Technical Service Information

THM 200-4R SECOND GEAR STARTS

Figure 1

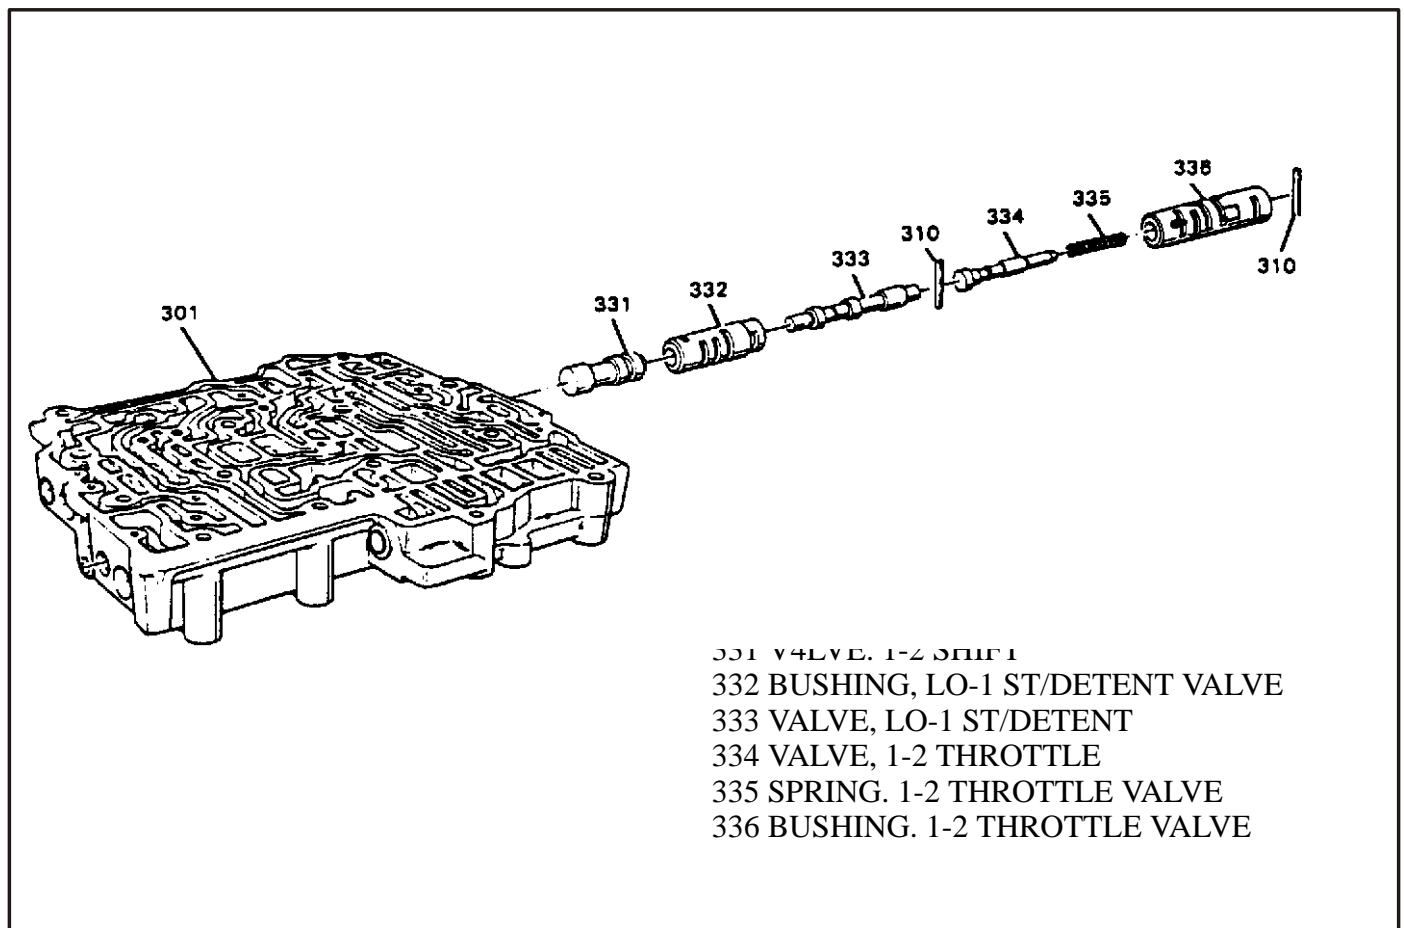
COMPLAINT: No 2-1 coastdown shift in cold weather conditions, and then may exhibit normal operating conditions after warm.

CAUSE: The cause may be an incorrect 1-2 throttle valve spring (See Figure 1). This affects ONLY 1987-1988 models CCF, CHF, CRF, CTF, CYF, and CZF.

CORRECTION: Replace the 1-2 throttle valve spring, available under OEM part number 8643619. Refer to Figure 1 for proper assembly of valves and sleeves.
